Planning Commission Staff Report

Project Type: Site Development Section Plan

Meeting Date: May 8, 2017

Description: **Larry Enterprises – Lynch Hummer, Parcel 1 (McBride Design Center):** Site Development Section Plan, Lighting Plan, Landscape Plan, Architectural Elevations, and Architect’s Statement of Design for a 3.1 acre lot of land zoned “PI” Planned Industrial District located on the west side of Boone’s Crossing on the north side of North Outer 40 Road.

SITE DEVELOPMENT SECTION PLAN

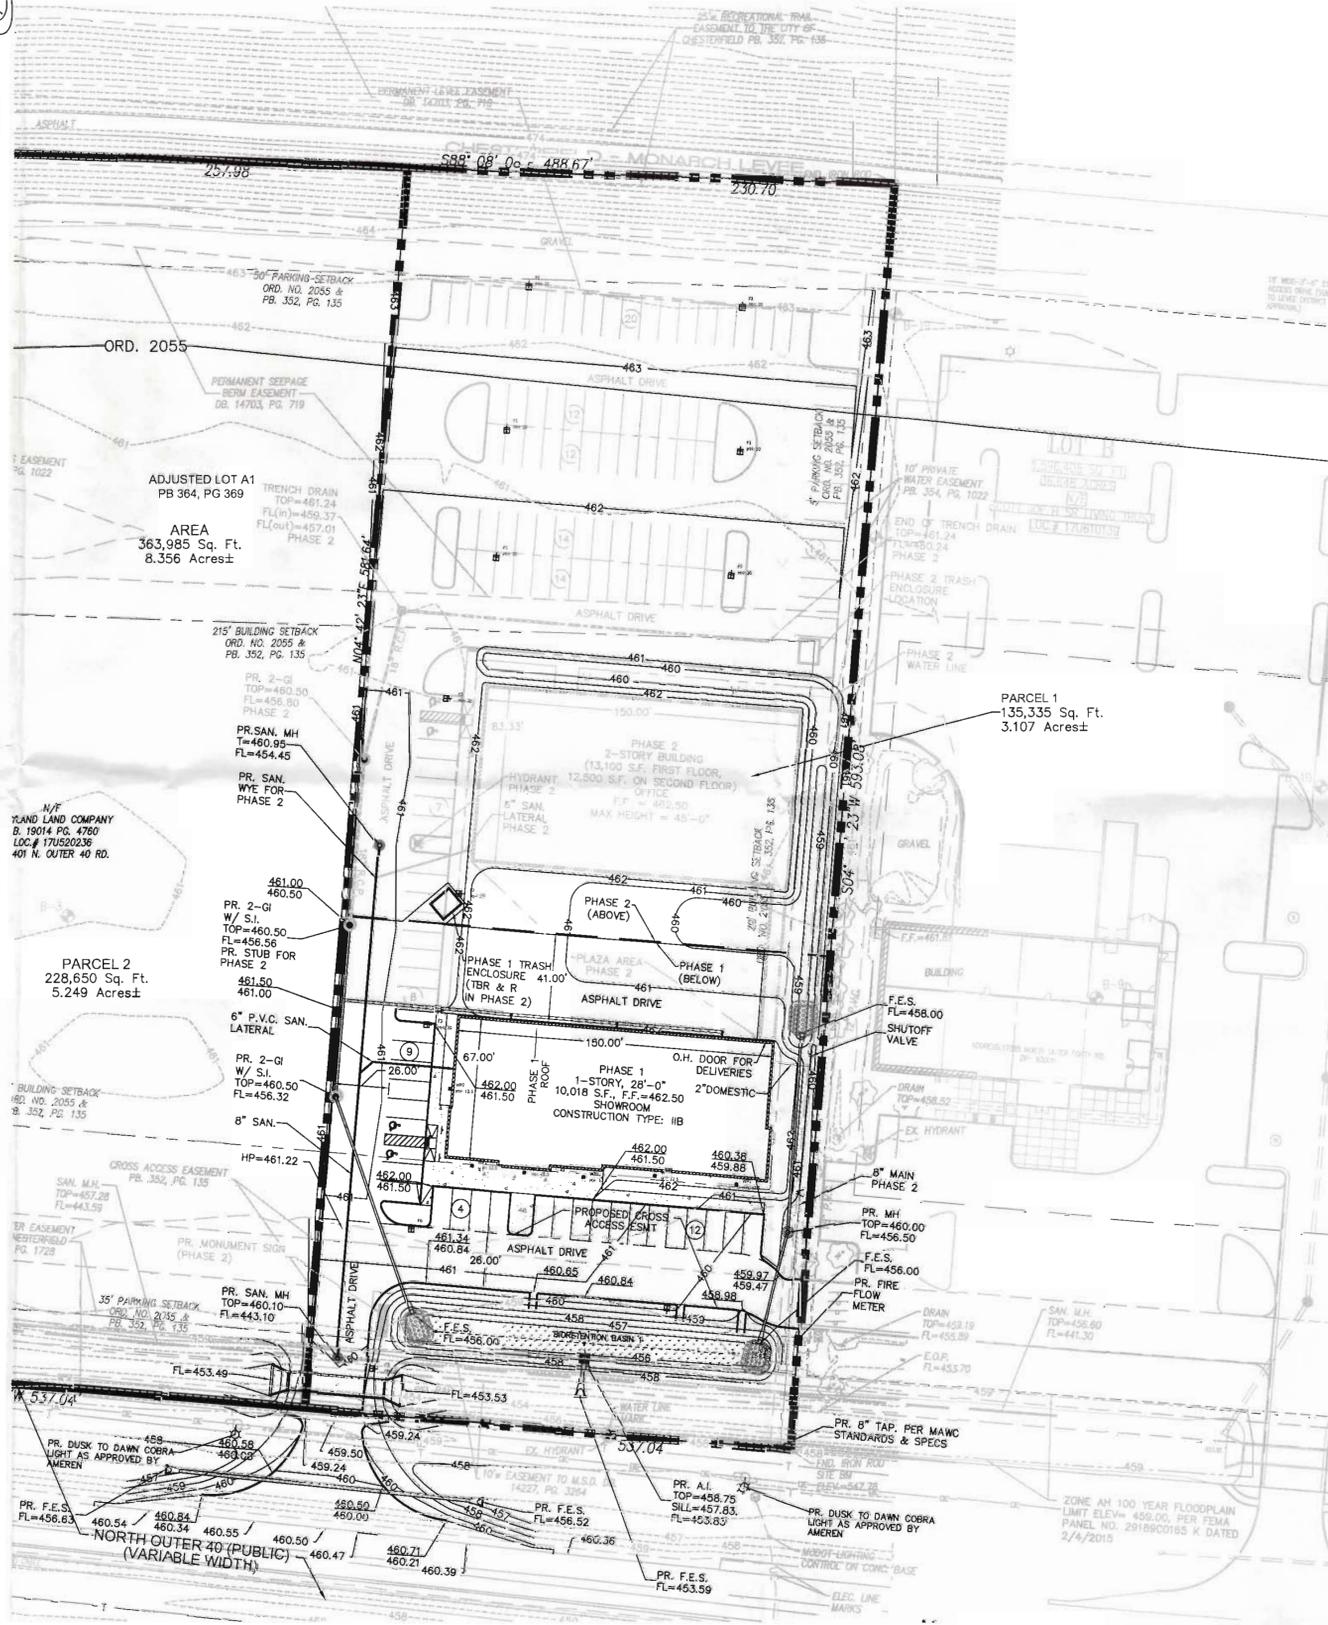
1. Consider clarifying/revising the trash enclosure proposed for Phase I of the development that is situated along the northern paving limits. Utilize landscaping to screen and soften the dumpster enclosure.

The motion passed by a voice vote of 3-0. The applicant complied fully with the Architectural Review Board's recommendation by relocating the dumpster to the location shown on the Site Development Section Plan and added shrubs along the exterior.
